Redesign of the MTS 5 for THR capability

Type of notification: ☒ PCN ☐ PDN ☐ Short-term action

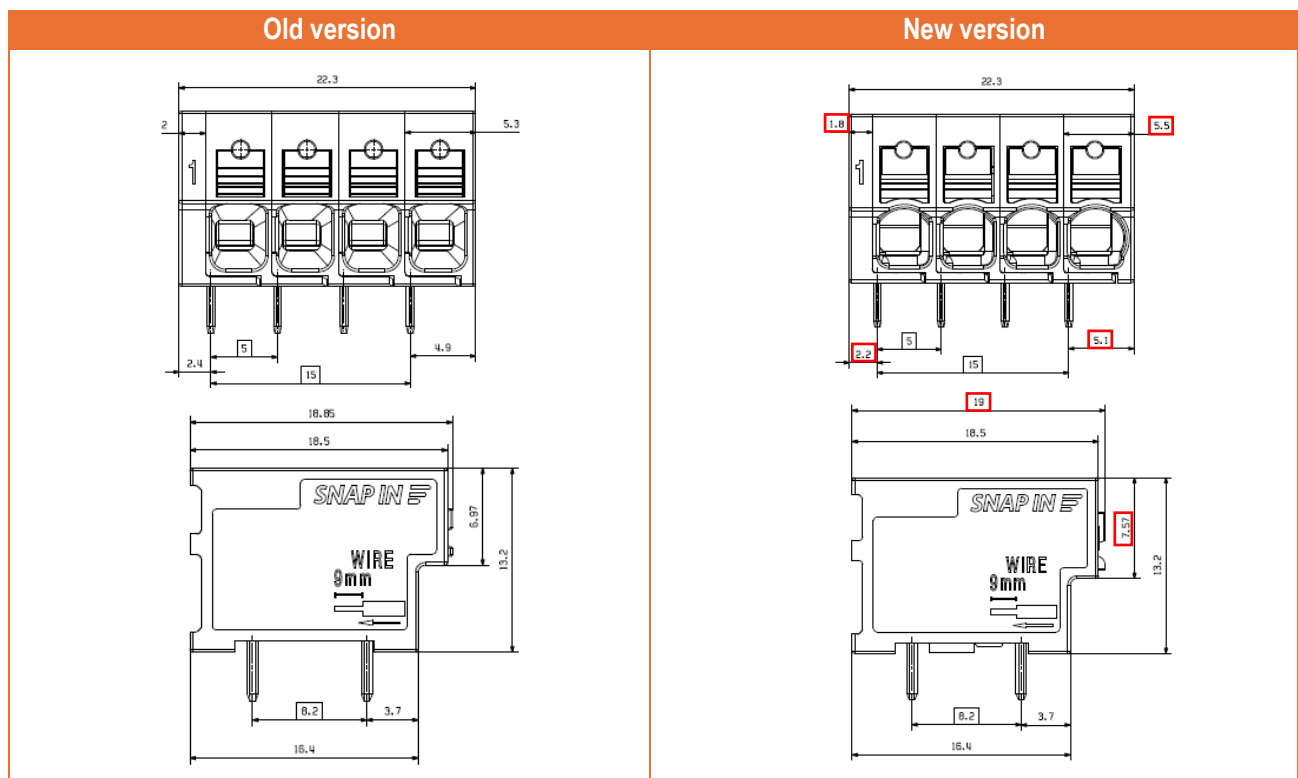
The new version of MTS 5 is optimized to increase the maximum temperature resistance of the product. As a result, the MTS 5 products can be used as before in THT soldering processes as well as for THR soldering processes thanks to the optimization. The external dimensions of the new version of the MTS 5 and the PCB layout of the solder pins remain the same, although the housing will be shift by 0.2 mm relative to the position of the solder pins as part of the product change.
